## ADA Analysis

**Self-evaluation and Transition Plan  
August 2017**

**Prepared by:**  
**Center for Living and Working, Inc.**  
**and**  
**James M. Mazik, AICP - Consulting Services**

Photo 5: First level office

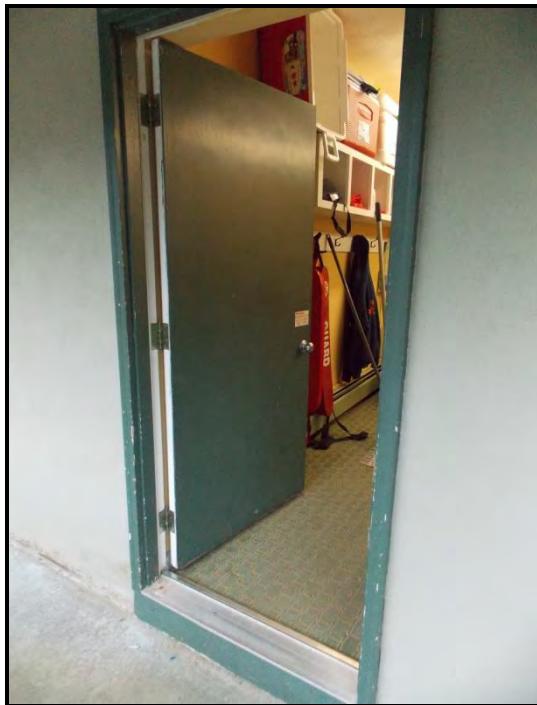
3. First floor office - lack of compliant accessible signage; abrupt change at threshold entry to office; knob-style door hardware. <b>See Photo 5.</b>	S. 403 S. 404 S. 703	S. 20 S. 22 S. 23 S. 26 S. 41	<b>Signage</b> –install accessible compliant signage on the latch side of the door with appropriate finish and contrast and character height and proportions, raised and brailled characters should also be included, signage should be mounted at 60" a.f.f. to the centerline of the sign with tactile characters a minimum of 48" a.f.f.; <b>door</b> – install lever style hardware; <b>entrance</b> – replace or modify existing threshold to eliminate abrupt change in level surface so that threshold is beveled or has less than a $\frac{1}{4}$ " differential.	1	2	I	Signage - \$50; Lever - \$100; Threshld - \$500.  Total: \$650
---	----------------------------	---	---	---	---	---	--
